Re: Questions from the FCC

FCC ID: NWJ10A001A
Correspondence Reference Number: 11037
731 Confirmation Number EA94679
Date of Original E-Mail: 12/15/1999

Figure 1. Page one of Panasonic Project Log (# 3252).

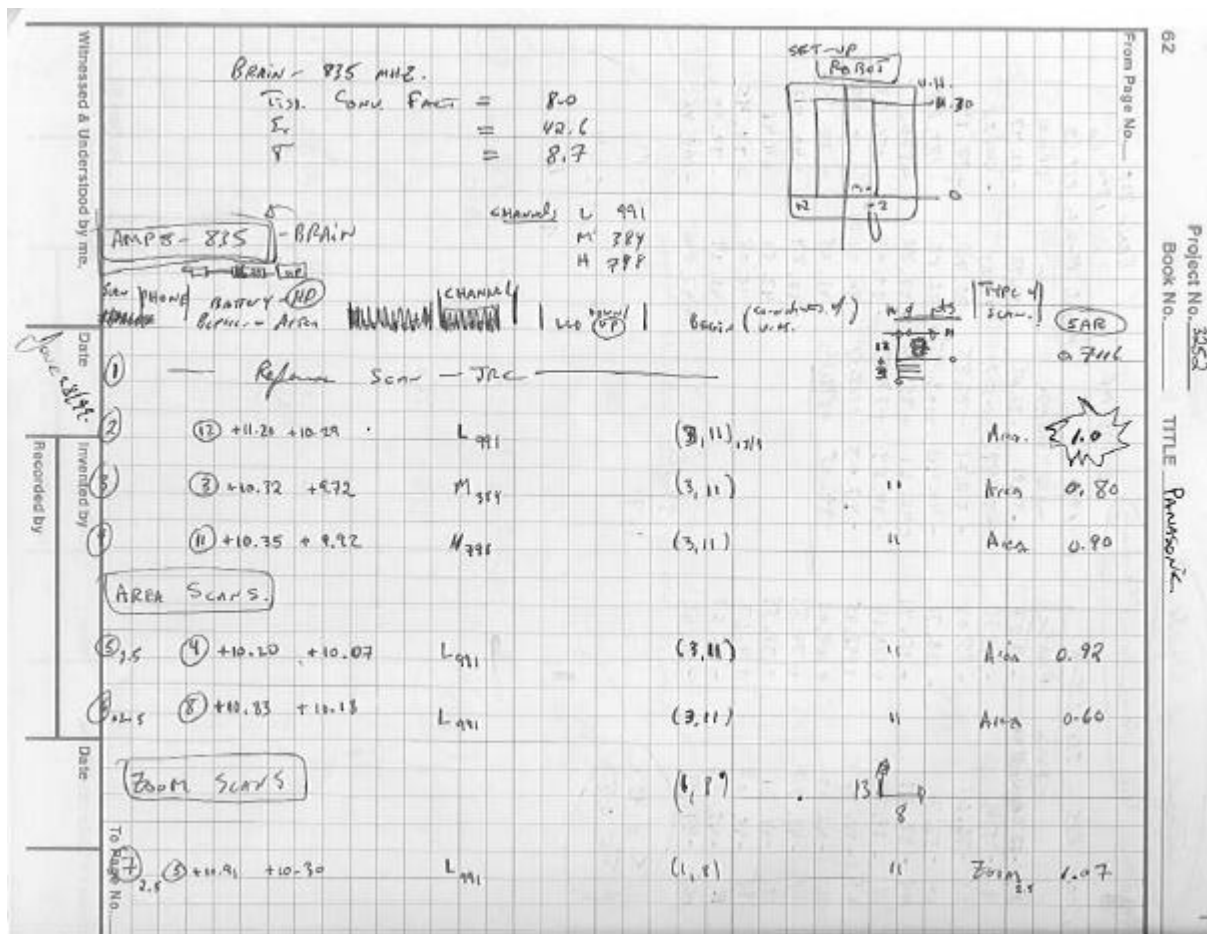
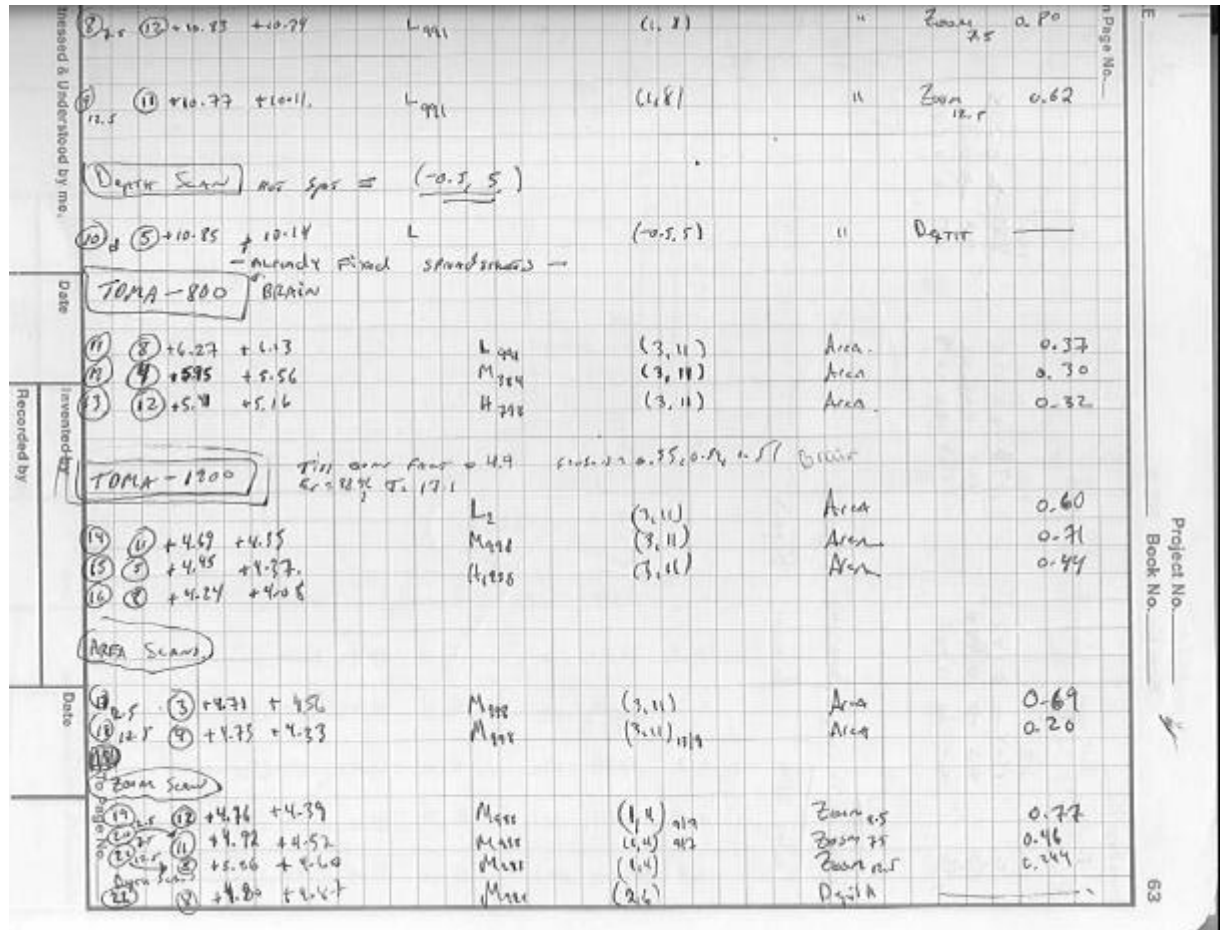
> -----Original Message-----
> From: oetech@fccsun07w.fcc.gov [SMTP:oetech@fccsun07w.fcc.gov]
> Sent: Wednesday, December 15, 1999 9:05 AM
>
> To: Pieter Seidel, Panasonic - MMCD
> From: Errol Chang, echang@fcc.gov
> FCC Application Processing Branch
>
> Re: FCC ID NWJ10A001A
> Applicant: Matsushita Mobile Communications
> Development Corporation of USA
> Correspondence Reference Number: 11037
> 731 Confirmation Number: EA94679
> Date of Original E-Mail: 12/15/1999
>
>
> 1. The conducted outputs indicated in response #1 for the cellular
> TDMA mode do not make sense, 5.16-6.27 ? Please submit a copy of the
> measured results for conducted output for this operating mode.

In the previous response dated November 22, 1999 by Panasonic the conducted outputs reported are the RF power meter readings measured by APREL Laboratories. To get the actual conducted power you have to add 15.15dB to account for the attenuators, cable loss, and power meter sensor correction factor (as per note below table in section 6.1 of each of the two SAR reports). The range of conducted power is then 20.31 – 21.42 dBm. Note that these are average power readings and since this TDMA operated on one time slot in three the peak transmit power within the slot

would be at least 3 times this. However, this was irrelevant during the SAR measurements as the purpose of these measurements was to determine the effect of the battery drain on the operation of the device. Below you will find scans of the two pages in Antonio Utano's labbook (APREL Notebook No. 286) logging the SAR measurements for the Panasonic EB-TX110A.

The first column notes the SAR scan number, the second the battery number used for this particular scan, the third column the power meter (HP 438A) reading at the beginning of this run and the fourth column the power meter reading at the end of the scan. Note that above the power reading column headings there is a small sketch of the RF conducted power measurement setup. This shows an estimated total correction factor of 16dB which was later determined to actually be 15.15dB.

The RF power readings reported in the previous correspondence dated November 22, 1999 can be found on the second page (see Figure 2 below) under a boxed heading of "TDMA 800" Brain.
